RE: Development Application - DA2021/0398

90 Lawrence Street Freshwater

Objections to Proposed Development – Secondary Dwelling

Figure 1: Site Plan Diagram - Rear Setback Non-Compliance

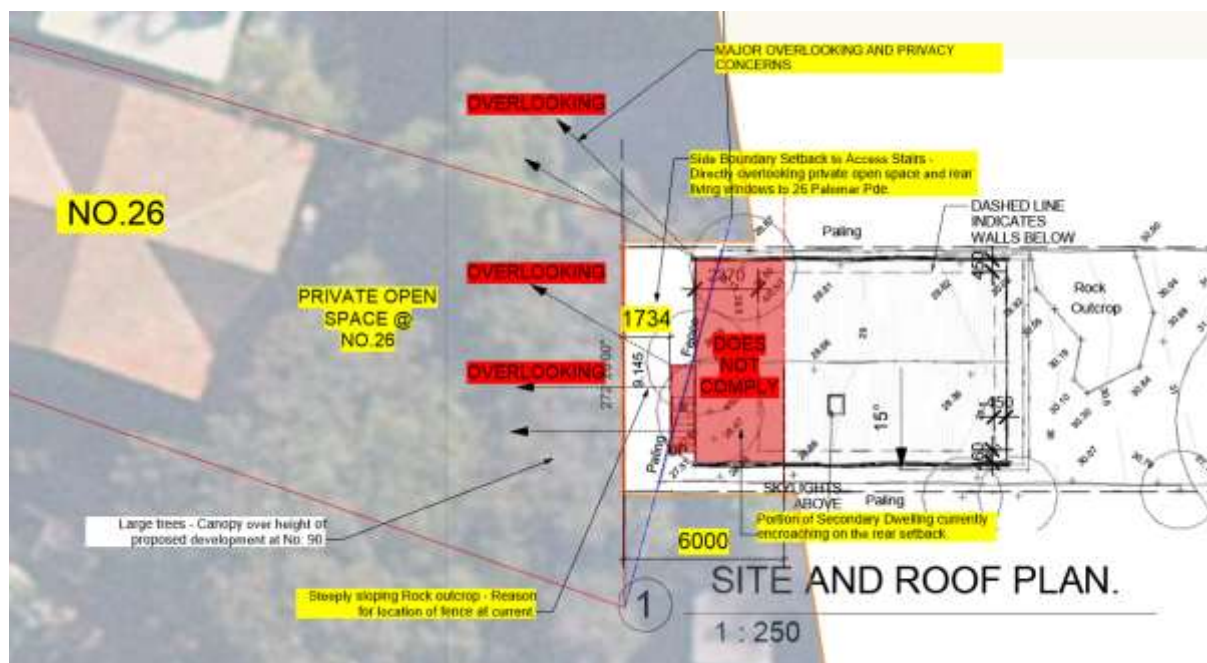
1. As shown in the diagram above, the proposal encroaches the rear setback with the access stair, landing, entertaining deck and from coming as close as 1.75m to the rear boundary. This will cause major overlooking, and major overshadowing to the Private Open Space @ No.26 and also directly look into the living, dining and kitchen areas facing the rear of No. 26.

2. The Access stair and landing – where the new occupants will enter and leave the property will have direct views into the living areas and private open space @ No. 26. This will be a source of noise, and generally affect the amenity of No.26. Also considering the ground levels the base of the stairs will be virtually inaccessible.

3. The Private open space of the Secondary dwelling is not directly accessible from the living area which does not meet the Warringah DCP controls, further to this, with the current proposal, the deck would become the main “useable” area and greatly affect the amenity for private use of all adjacent rear properties to 26 Palomar Pde.

4. There are a number of native trees - proposed to be removed - very close to the proposed development, these 3 trees are all shown as greater than 7m in height according to the supplied survey. This will both impact on the privacy to No. 26, but also the current bushland scenic value and character of the area. We suggest these should be maintained as per the Objectives set out in the WDCP -B9.

5. The slope of the land at the rear is characterised by outcrops of rock, has a Geotechnical report been supplied to ensure that No.26 is going to be unaffected by the proposed building foundations.

6. As the existing fence will be removed, How will a new boundary fence be constructed – due to the lay of the land, it will likely require a retaining wall. Especially considering that the neighbours are building a secondary

dwelling, this needs to be addressed for privacy and obvious security reasons. (This could have been discussed if No. 26 was approached)

7. It was noted that a variation to the 6m setback was proposed in the Statement by RK Design to 5m and it was stated that *“There are no effects of shadowing, bulk or scale or adverse effects on the local environment.”* This is grossly incorrect and shows a lack of understanding for the site conditions and neighbouring properties. As we have already outlined in the above points and diagrams.
8. The survey provided notes that the area beyond the existing fence and site boundary is “not surveyed”, while the proposed secondary dwelling is to be located in this area – the height therefore in the section is wrong and actually slopes down greatly from the fence line towards No. 26. Exacerbating the loss of private amenity, and creating major overshadowing to the rear yard @ No. 26.

Figure 5. Section Overlay to supplied by RK Design - showing actual Natural Ground line & Encroachment to Rear Setback.

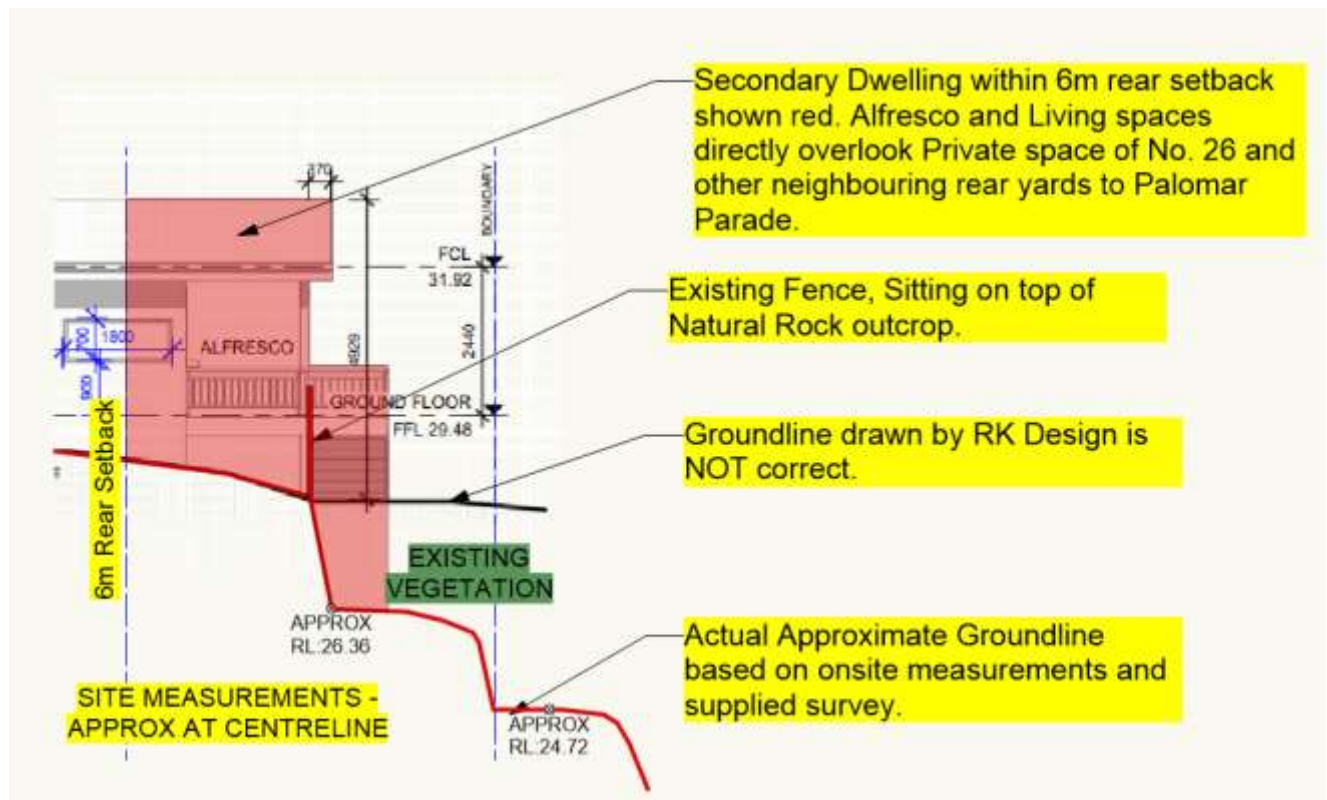
Additional Section From onsite calculations:
